MS9447  
AMENDMENT 1  
8 July 2003

BOLT, MACHINE-STEEL AMS 6304, DIFFUSED NICKEL-CADMIUM,  
PLATED, HEXAGON HEAD, DRILLED, .625-18 UNJF-3A

This amendment forms a part of MS9447, dated 21 December 1962, and is approved for use by all Departments and Agencies of the Department of Defense.

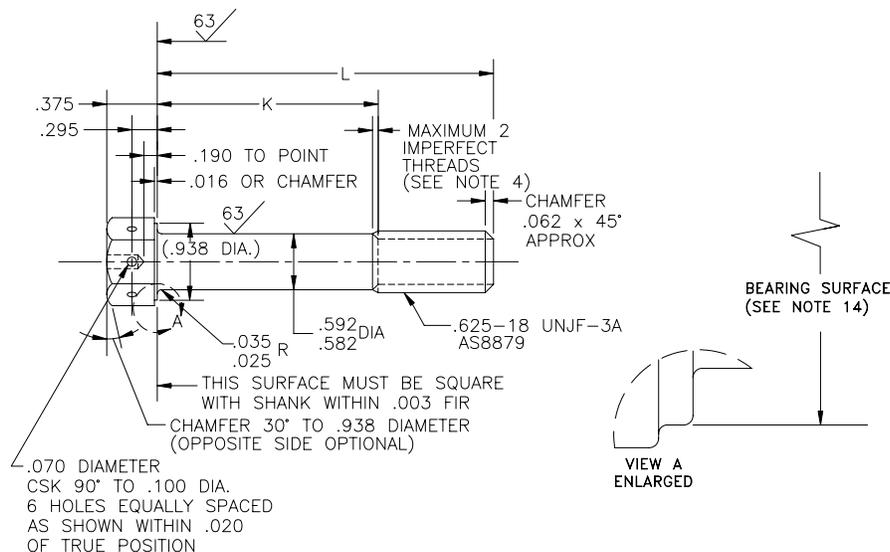
In drawing: Replace front view with this drawing and add view A:
